**Changed Pages**

**Part III, Appendix III-D.3**

**Landfill Design and Details**

**Pescadito Environmental Resource Center**  
**MSW No. 2374**  
**Webb County, Texas**

LINER PLAN

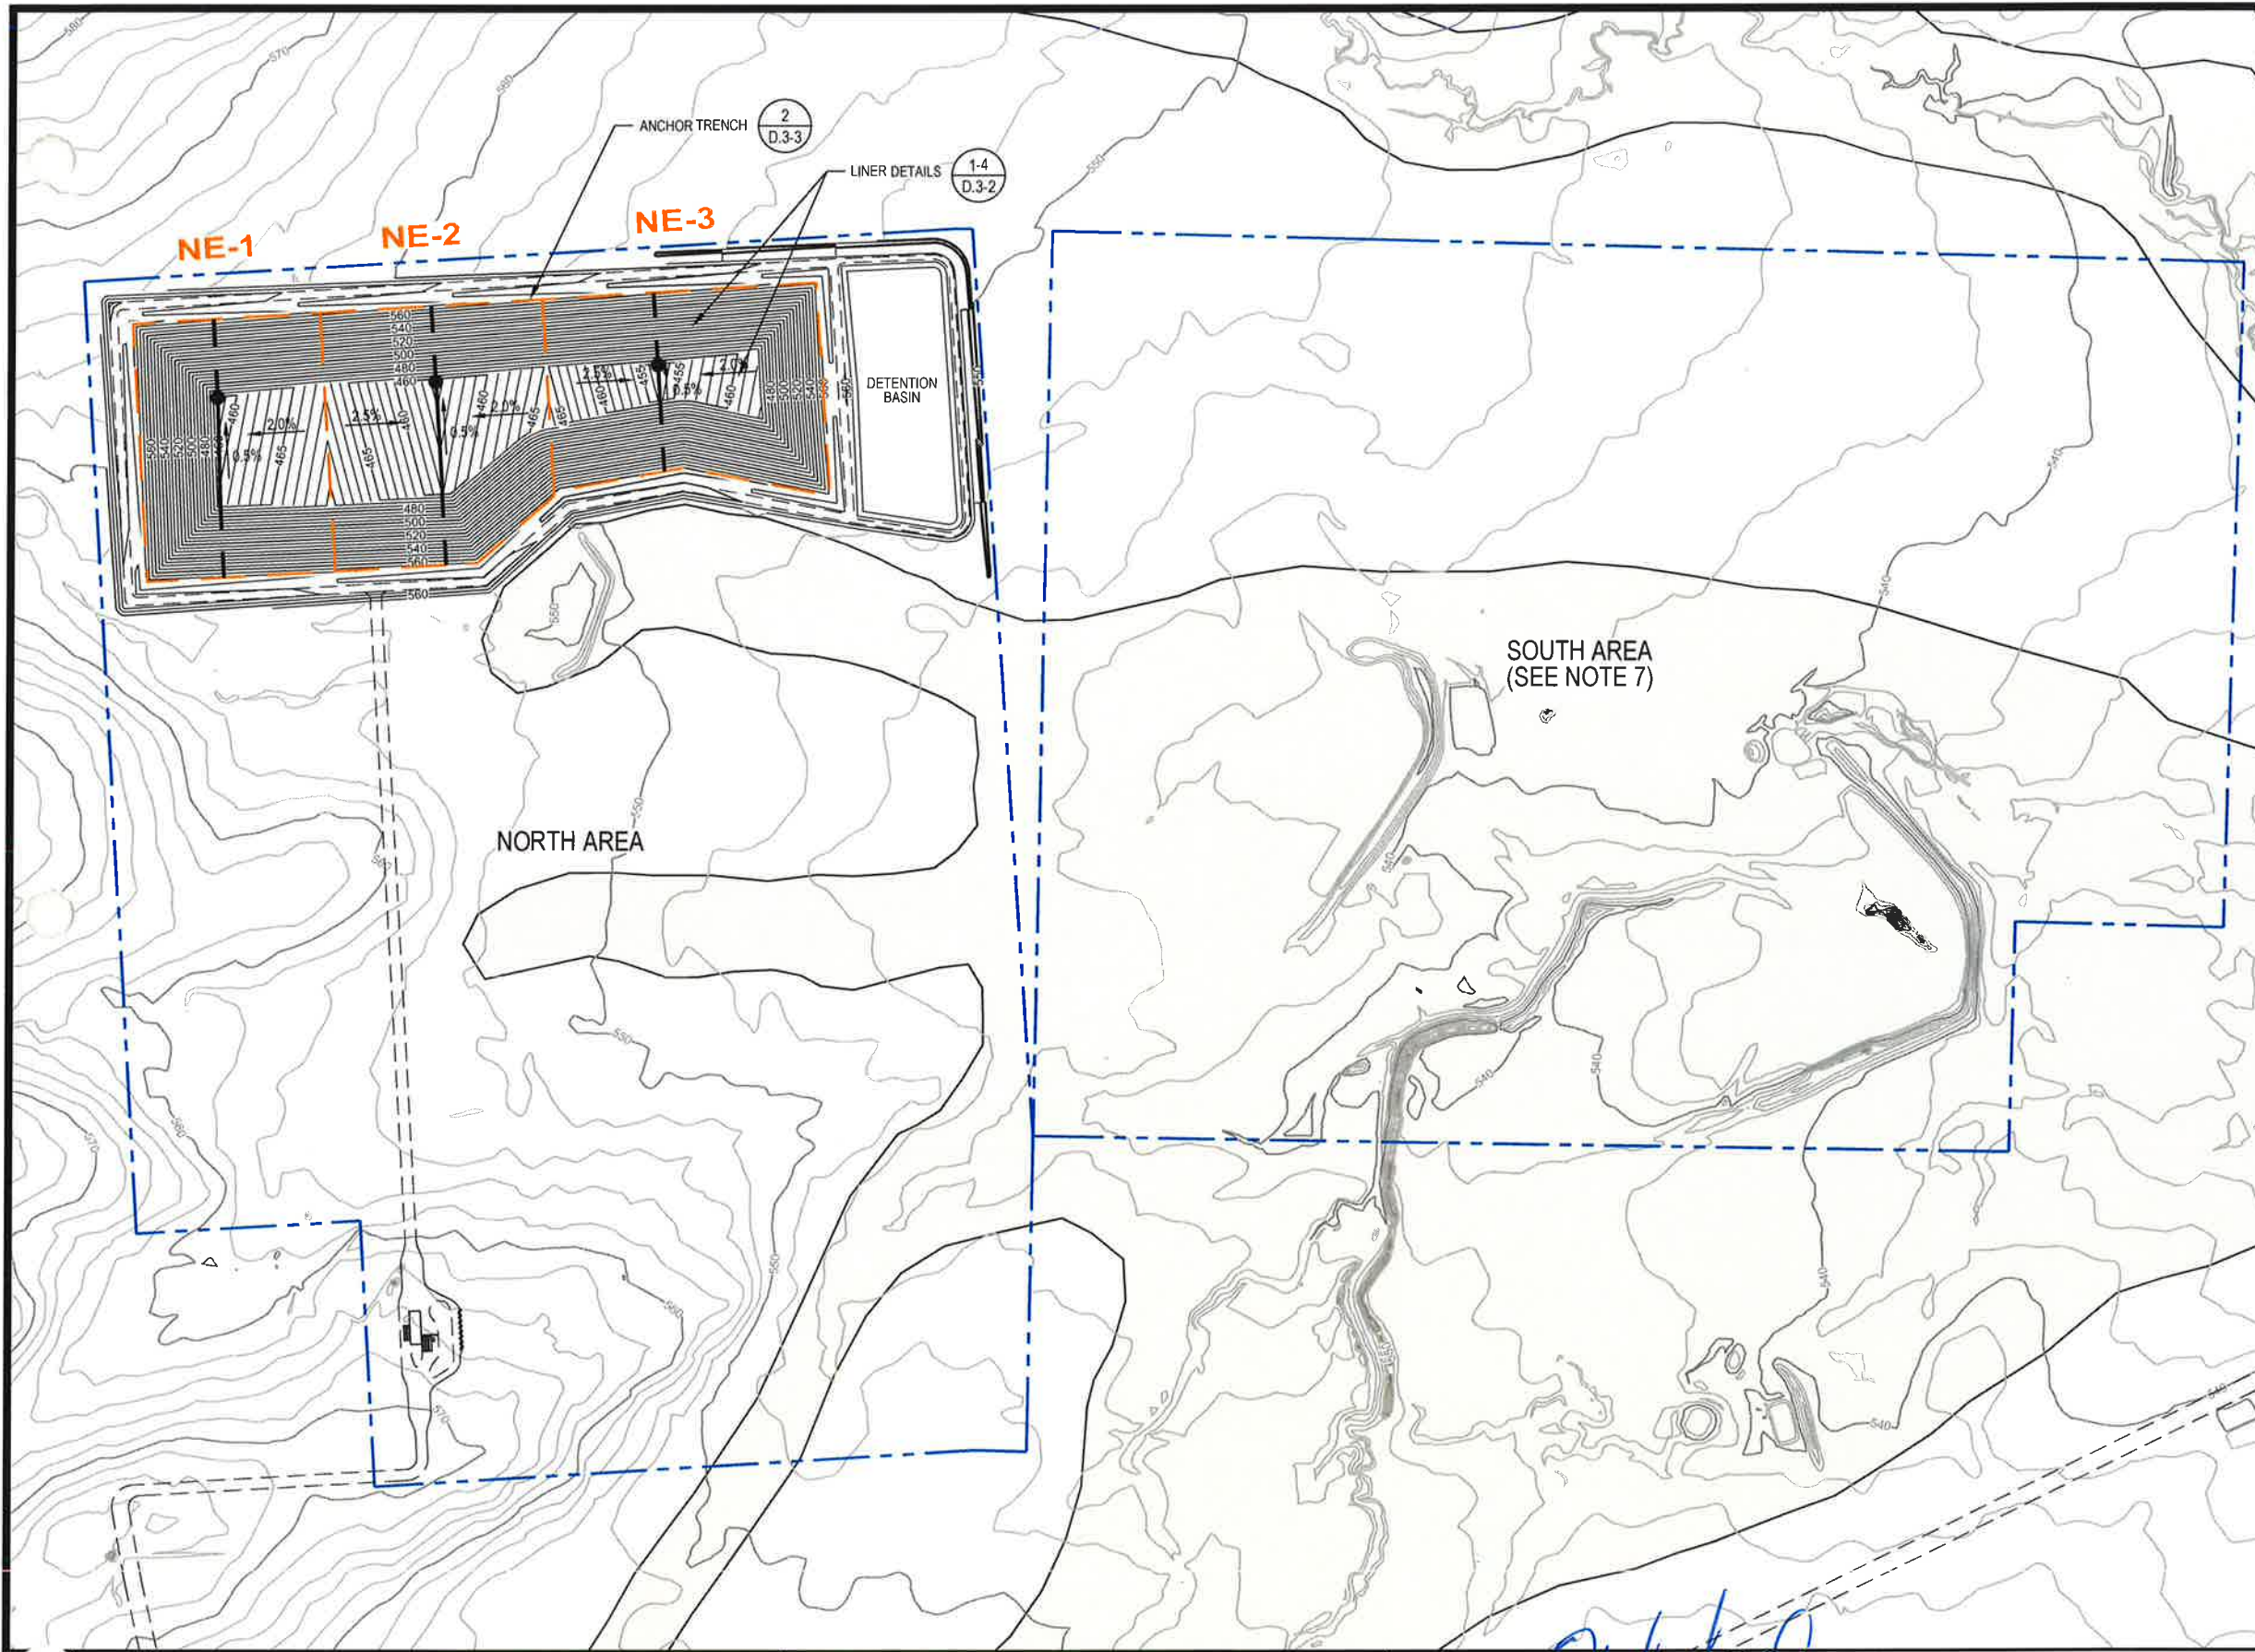
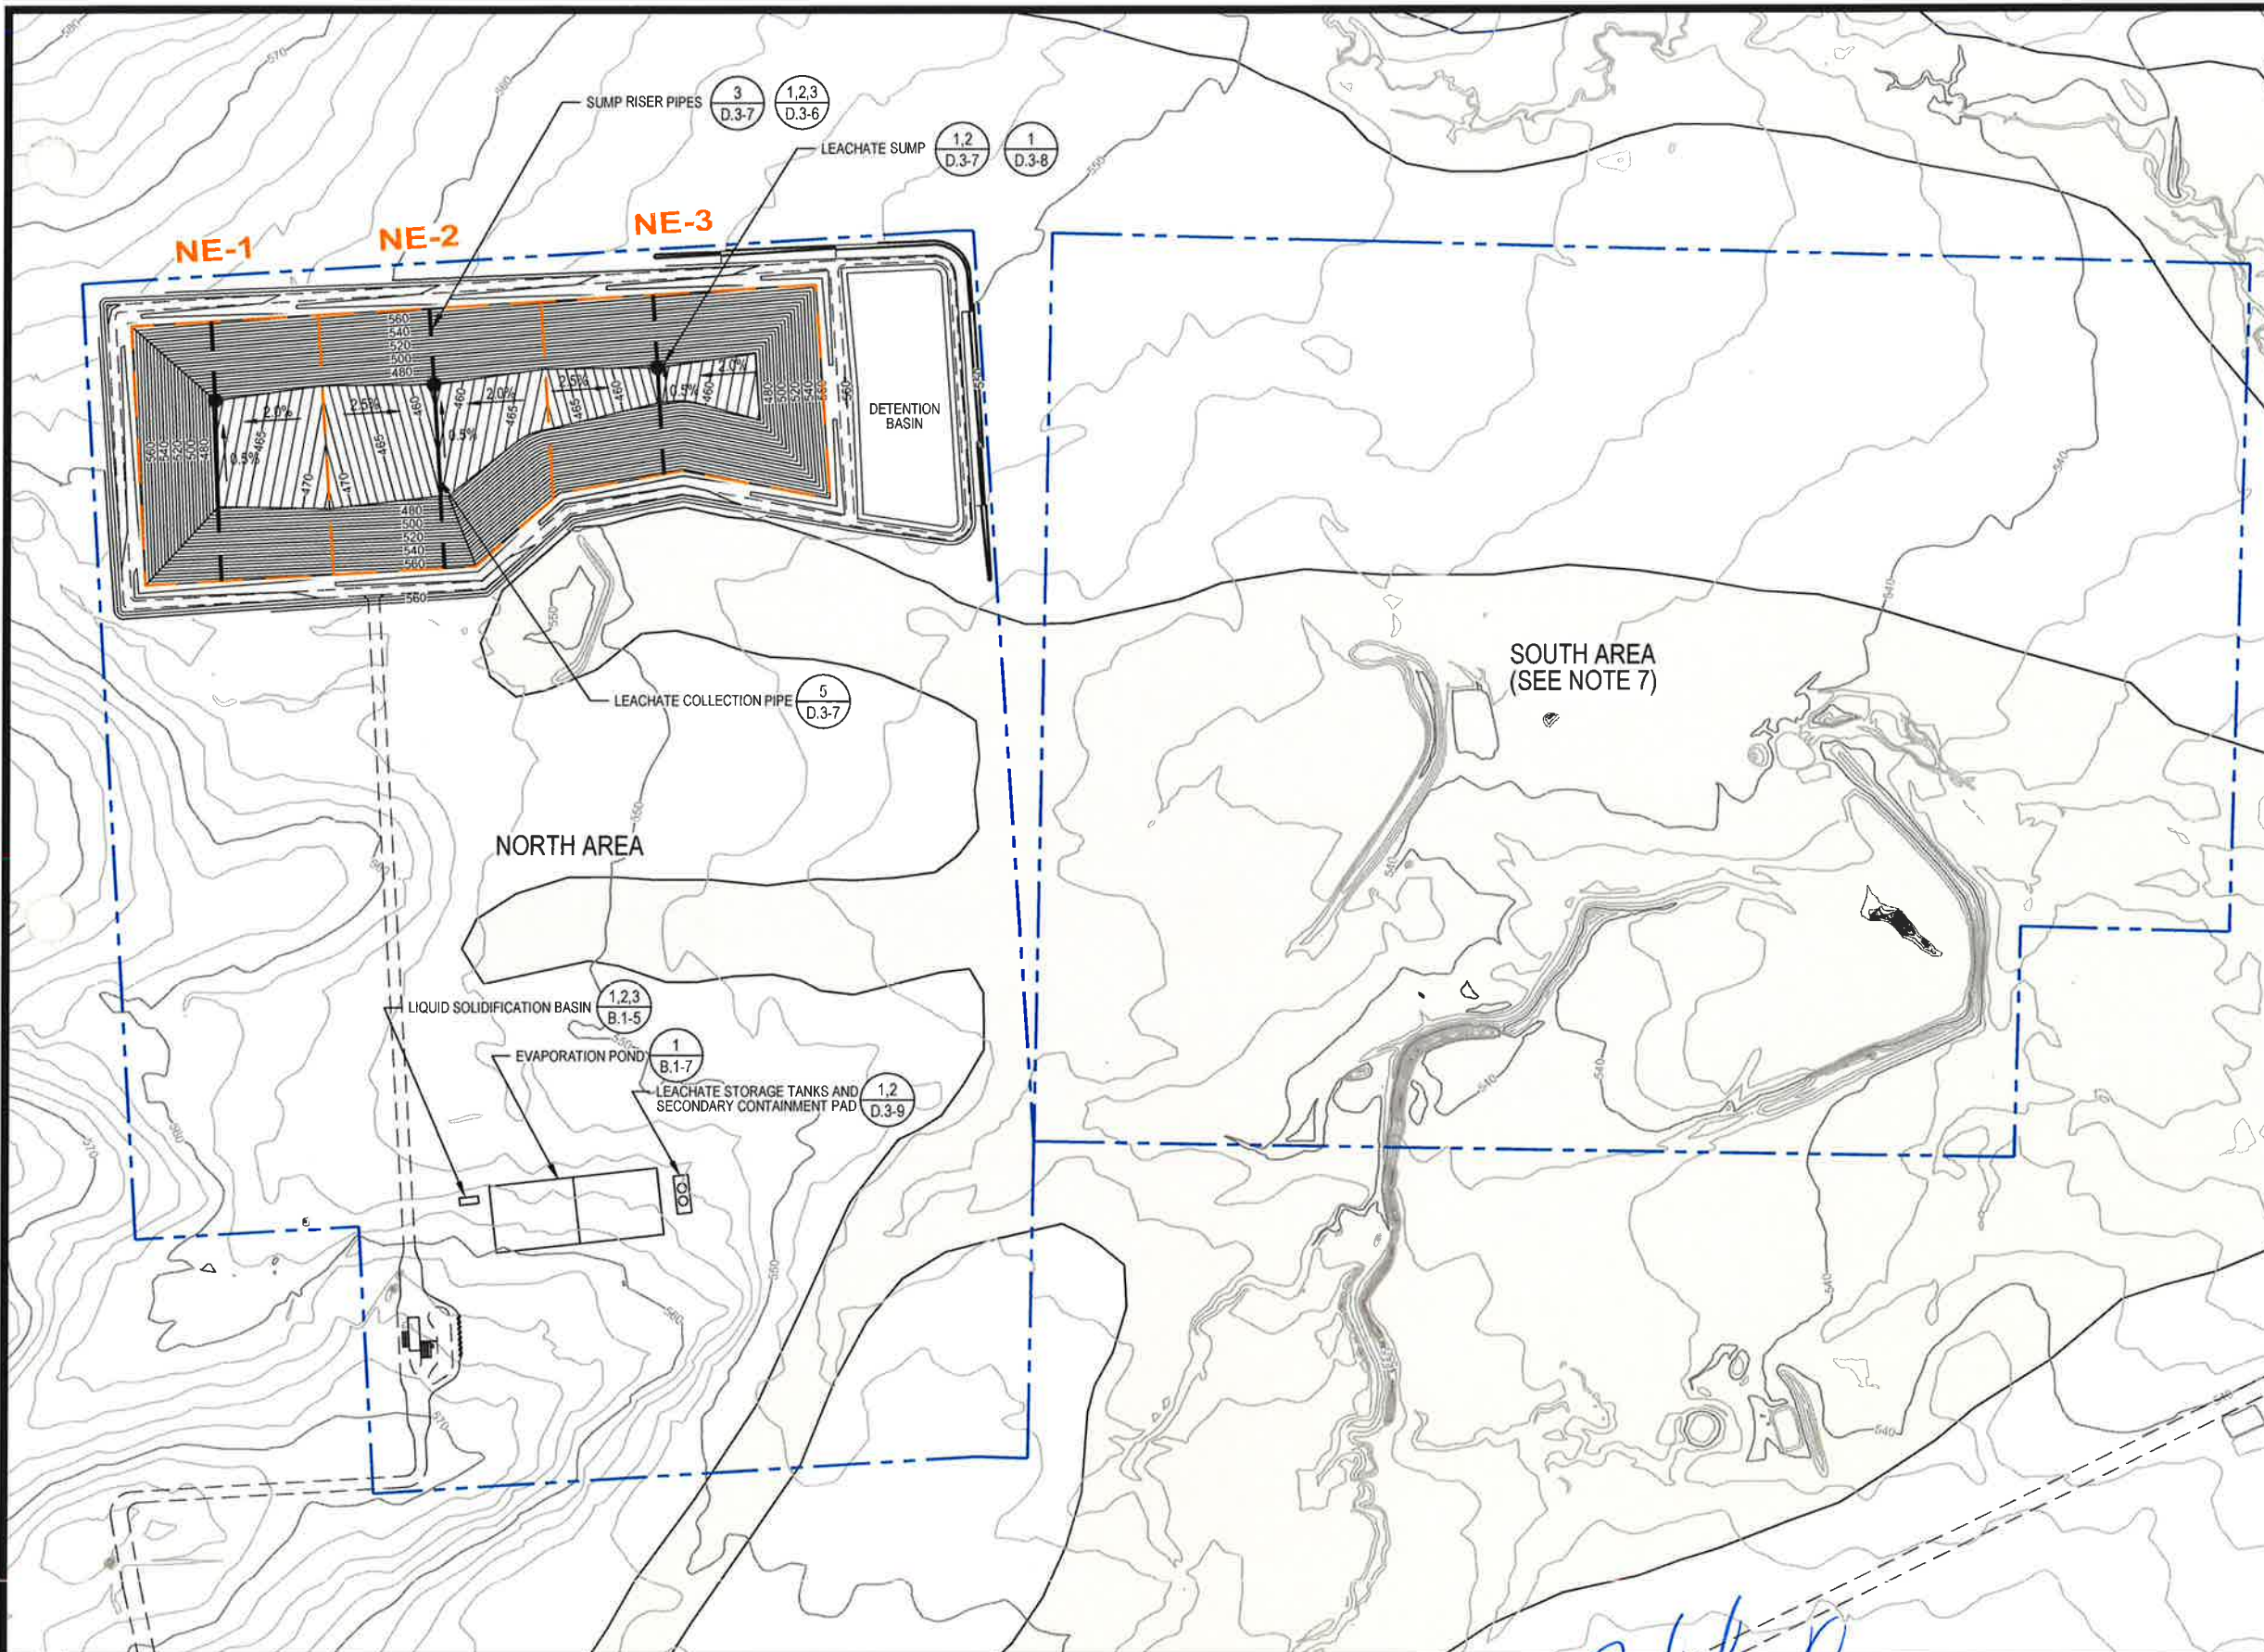
REV. NO.	DATE	DESCRIPTION
1	08/2017	REVISED WASTE UNIT BOUNDARY

**LEACHATE COLLECTION SYSTEM PLAN**

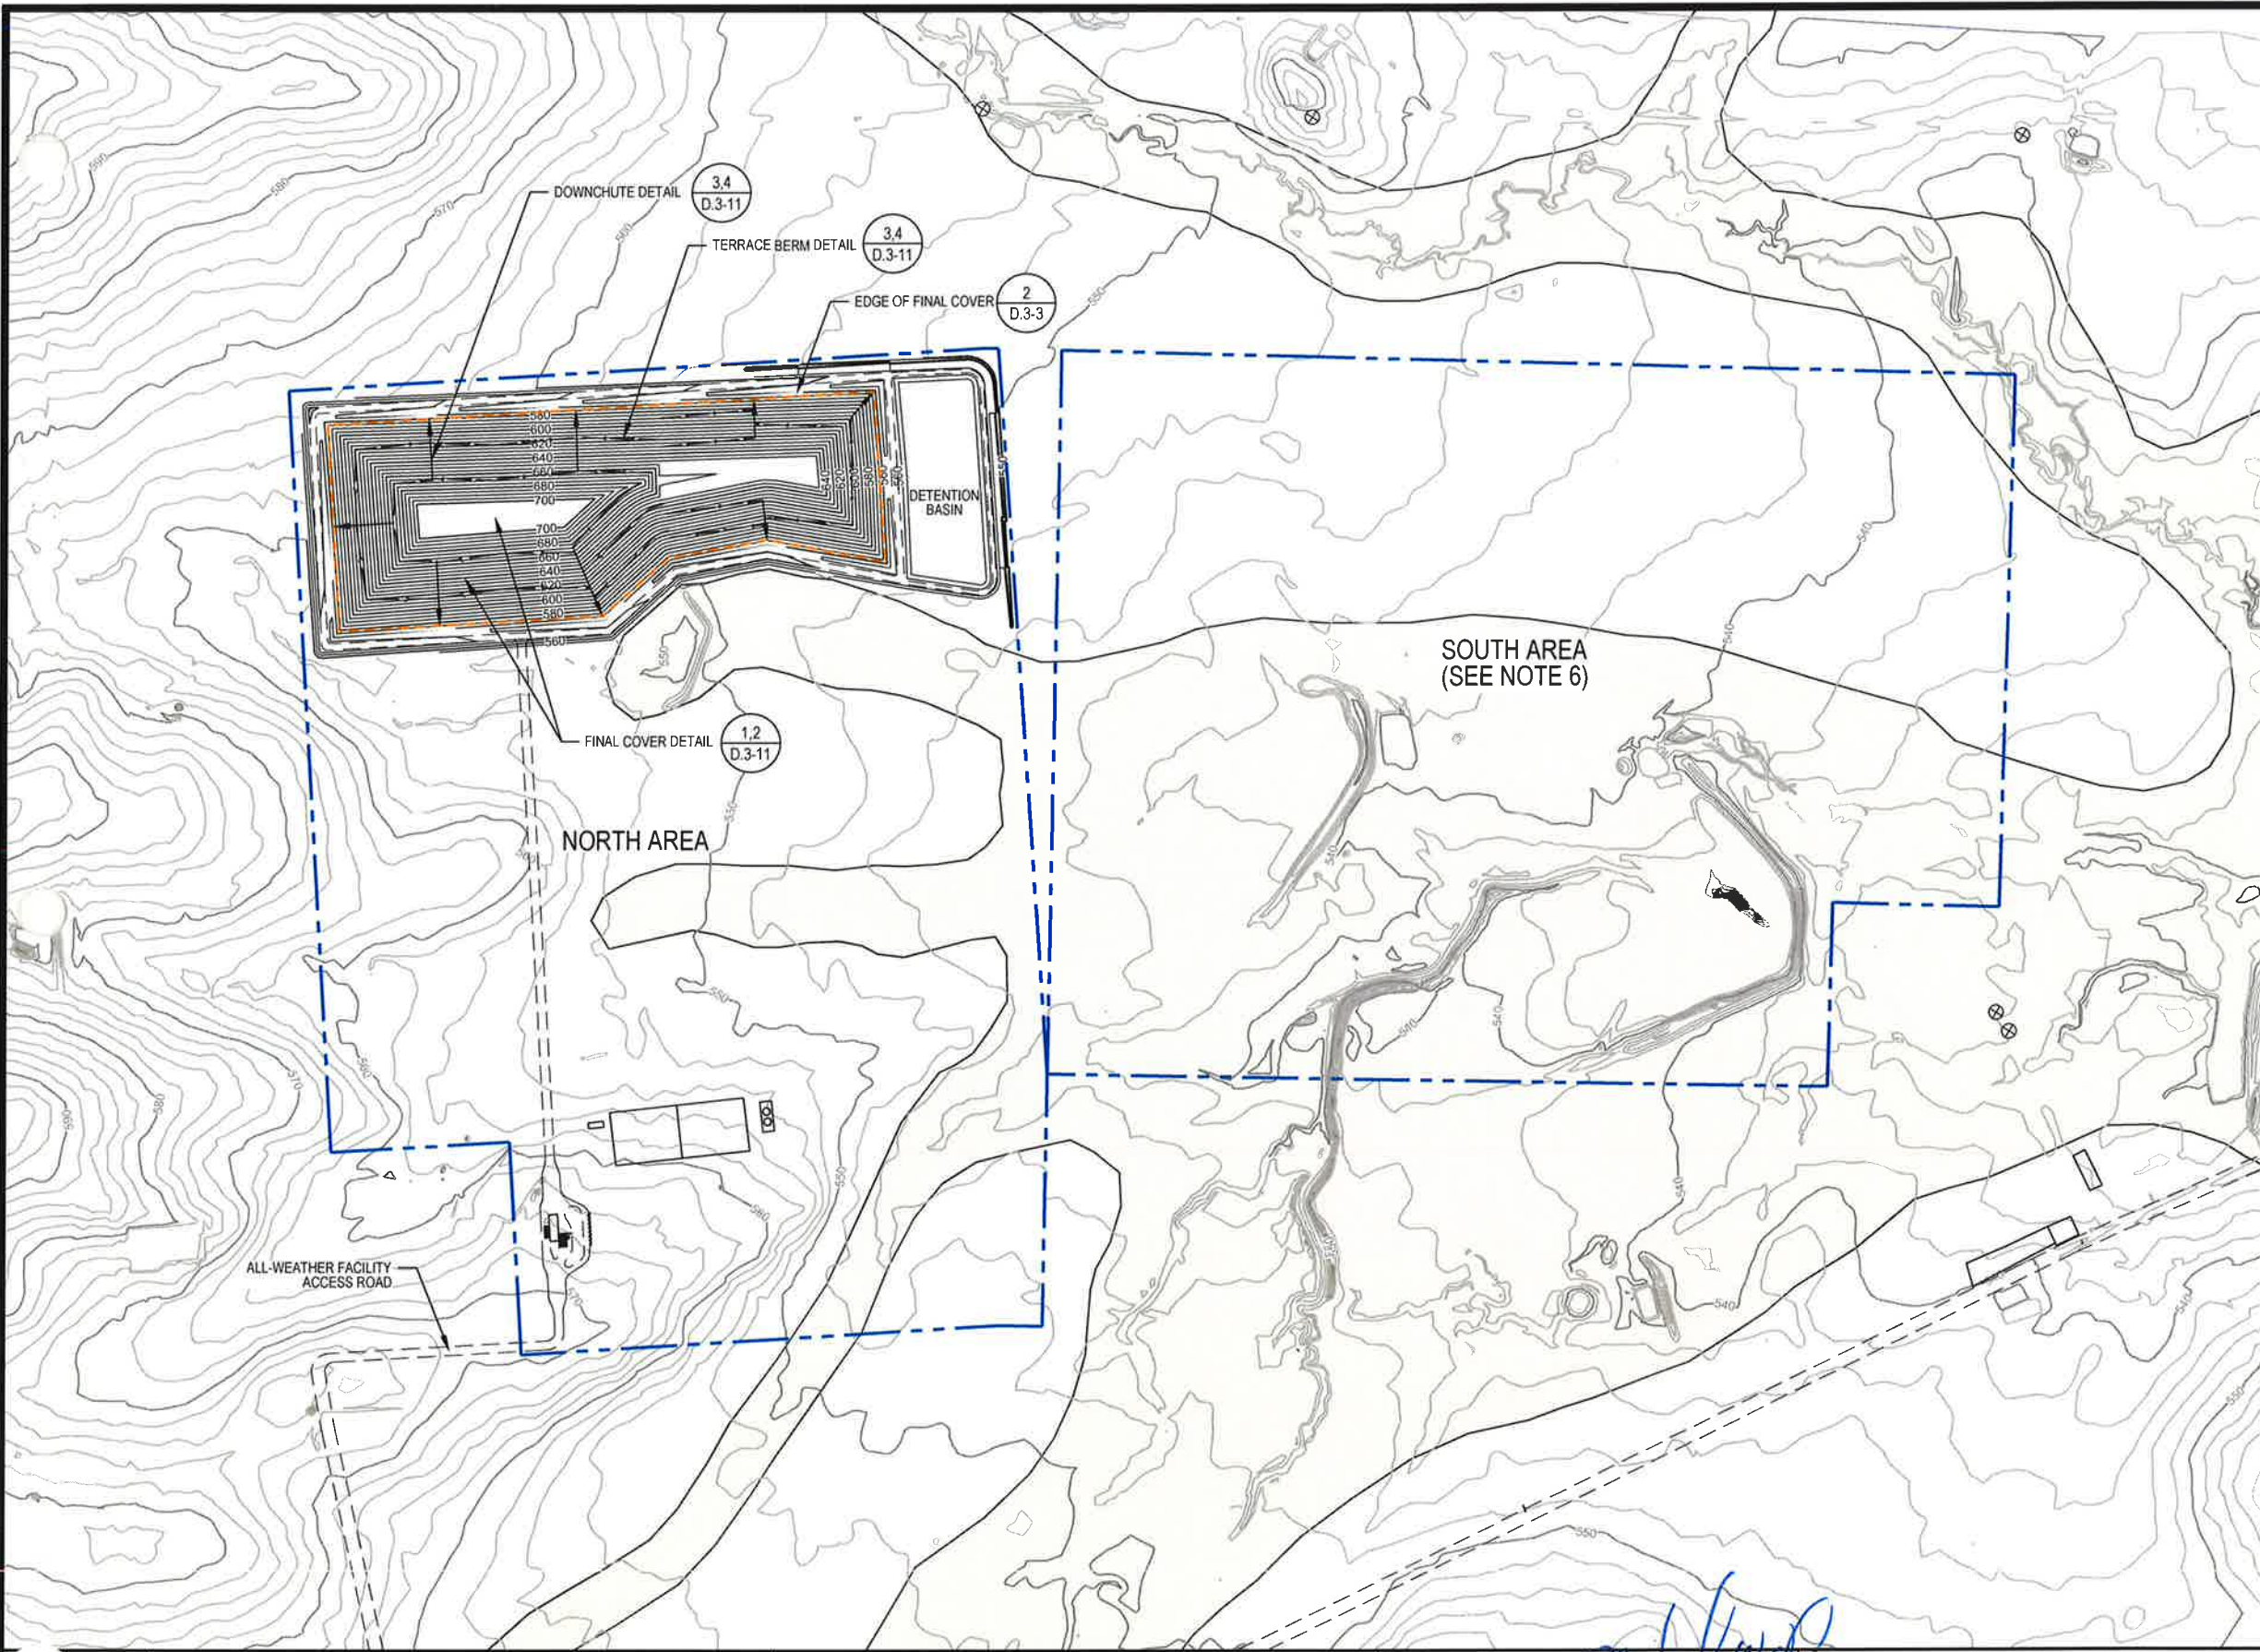
REV. NO.	DATE	DESCRIPTION
1	08/2017	REVISED WASTE UNIT BOUNDARY
